Anchor Run Stream Restoration

Photographs of Project Area
Taken March 13, 2026

Modifications Presented to PADEP for Approval

Revised Grading Plan
Based on PADEP Approved
Modifications

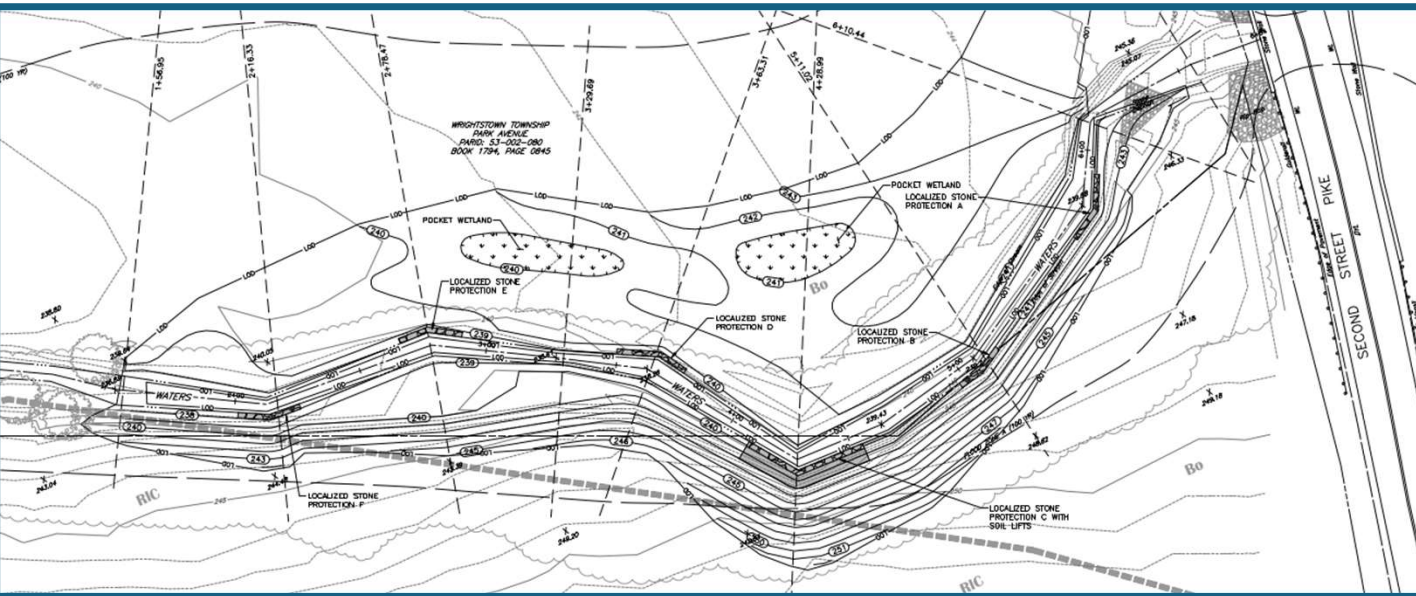
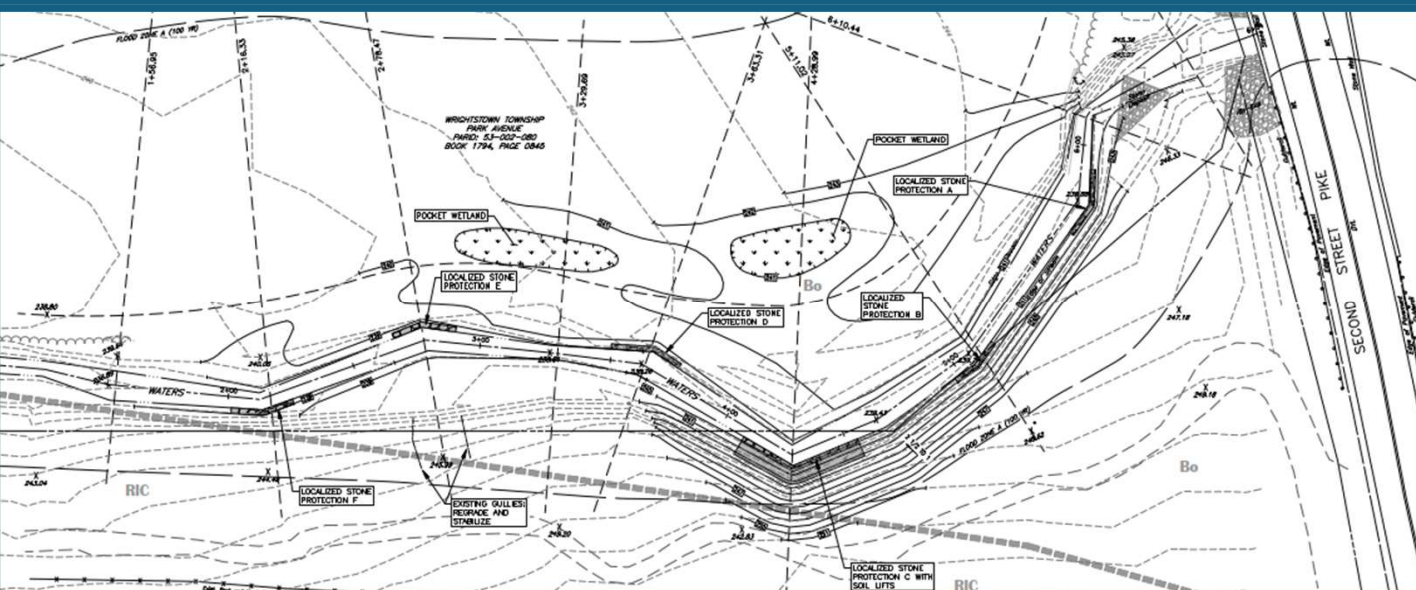
- Modify the proposed slope along the steeper section of the southern streambank from 3:1 to 2.5:1 to lessen the impact. There was bedrock visible in the stream at this location. However, it does not extend up into the streambank. We still propose planting the slope with trees and shrubs for the riparian buffer. The arrangement of plants may be modified.

- Eliminate the grading on the slope where there is an existing floodplain shelf along the southern side of the stream. The existing trees would generally remain to continue to stabilize the bank. There were two gullies noted between the trees that would be regraded and stabilized and any eroded areas directly along the edge of the stream would still be addressed.

- Modify the location where the water from the floodplain on the northern side of the stream would be directed toward the stream in order to keep the 2 existing 12-inch trees along the streambank.

These modifications to reduce the impact to existing trees and slopes were approved by the MS4 Group at PADEP stating that the revised project would still receive the same credit.
